ADDENDUM NO. 2 TO PROJECT NO. 44303

HVAC WORK AND ELECTRICAL WORK

**REPLACE ABOVE GROUND HOT WATER PIPING
MARCY CORRECTIONAL FACILITY**

March 6, 2013

DWG NO: E-101.1

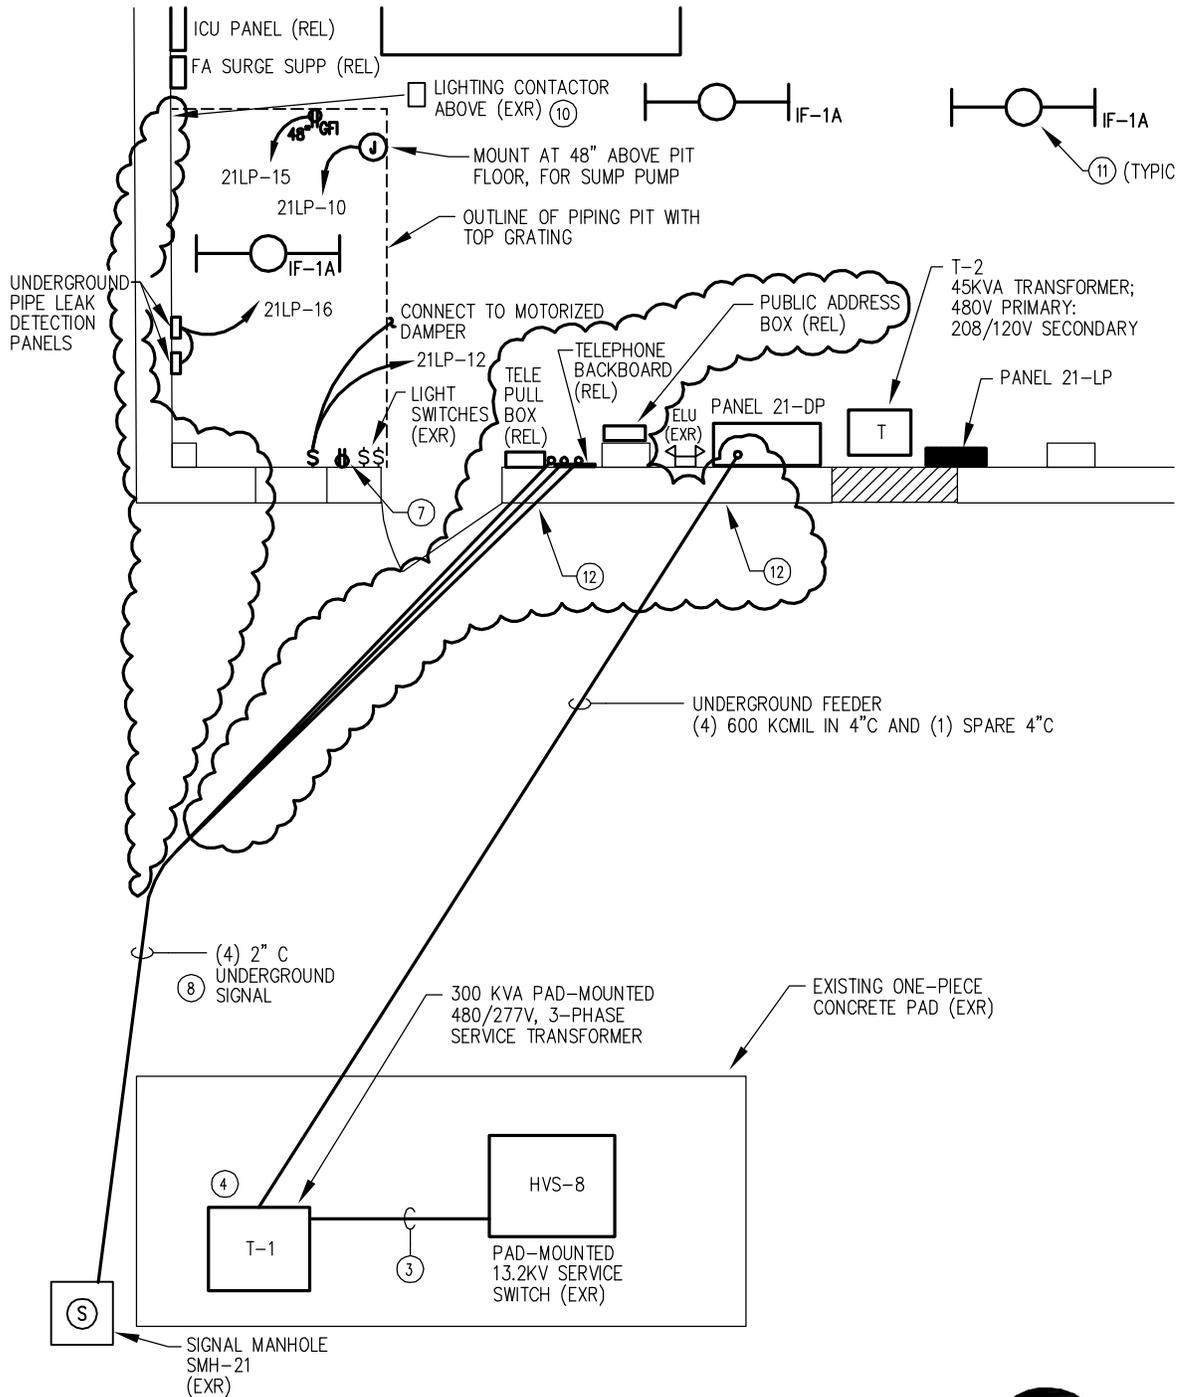
- e. Revise drawing per attached 8-1/2”x11” addendum sketch E-101.1 ,dated 3/5/13.
